## APPENDIX B

### Summary of DRA Analysis of Late-Filed ALJ Exhibits

#### A. Estimation of hydrotest costs used to calculate disallowances for pipe replacement projects

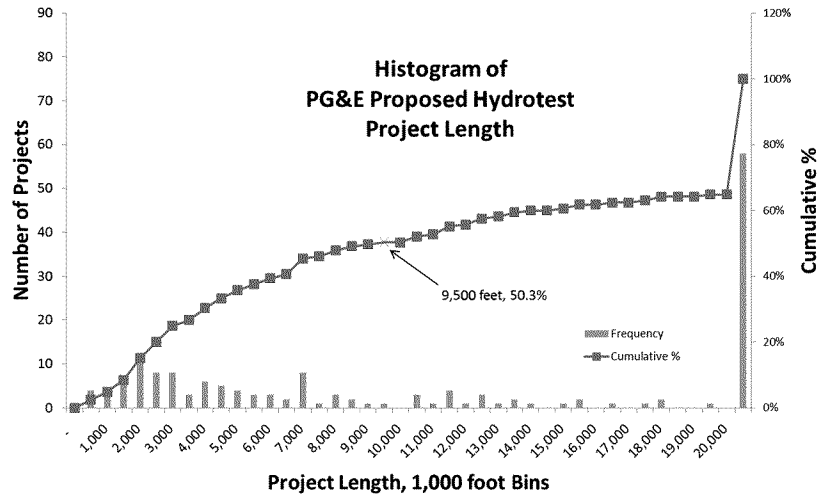
In addition, the record shows that hydrotest costs per foot decrease with increased length of a project, as fixed costs are spread over a larger length of pipe. The following chart shows hydrotest costs per foot for PG&E’s 165 proposed hydrotests projects, as a function of the length of each project:

This chart shows that short test projects, including all those shorter than 10,000 feet, have a cost per foot higher than \$95.8.

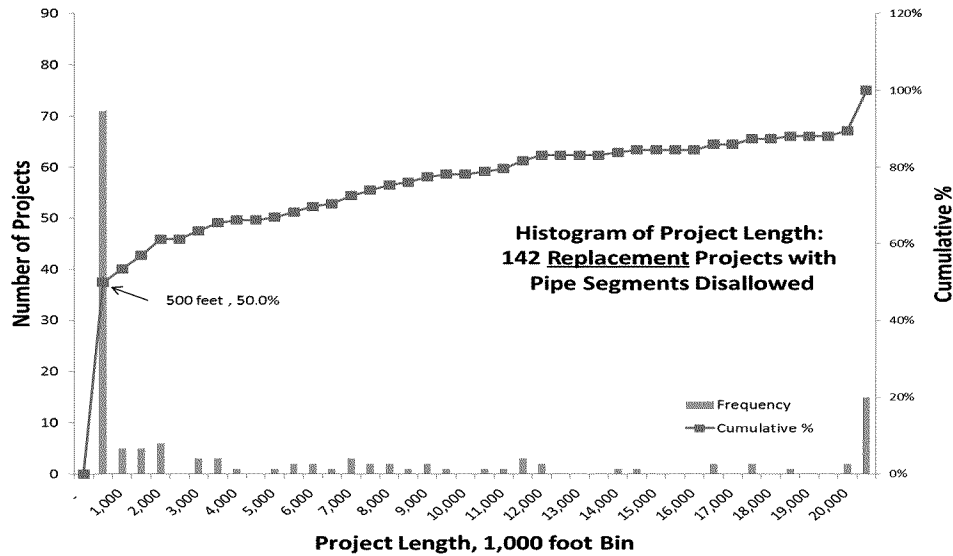
In comparison, the median length of PG&E’s proposed *replacement* projects is 509 feet, over 17 times less than the median length of *hydrotest* projects:<sup>12</sup>

This chart shows that the majority of proposed *replacement* tests (84 of 168) are less than 1,000 feet long.

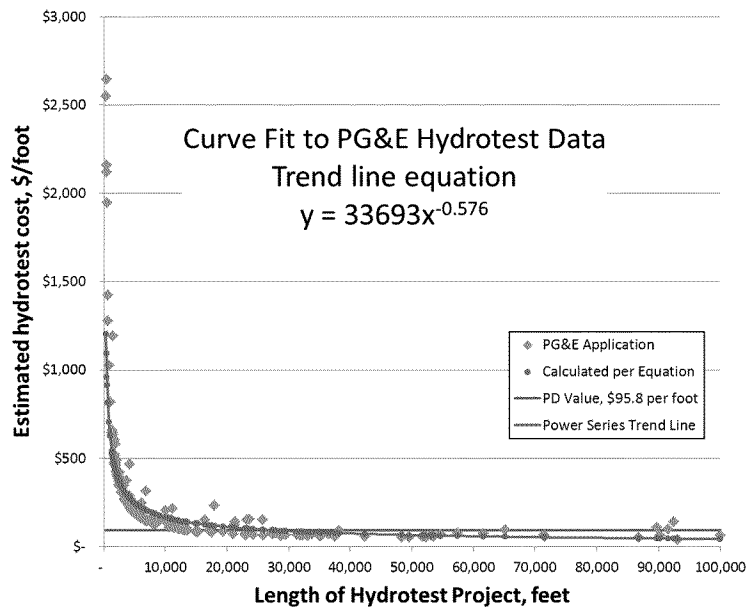
Not all replacement projects have segments that are disallowed, regardless of whether PG&E or DRA’s cost allocation criteria are used. DRA therefore performed a similar analysis on the 142 replacement projects with disallowances using the criteria of Scenario 3 as described in Section II.A.2(a) of DRA’s Comments on the PD.<sup>13</sup> The median value of these projects, 512 feet, and the frequency distribution are similar to the full set of replacement projects:<sup>14</sup>

This data shows that PG&E pipe *replacement* projects are much shorter than *hydrotest* projects, and that the single estimated hydrotest cost of \$95.8 per foot is inappropriately low for use for replacement projects, the majority of which have short pipe lengths.
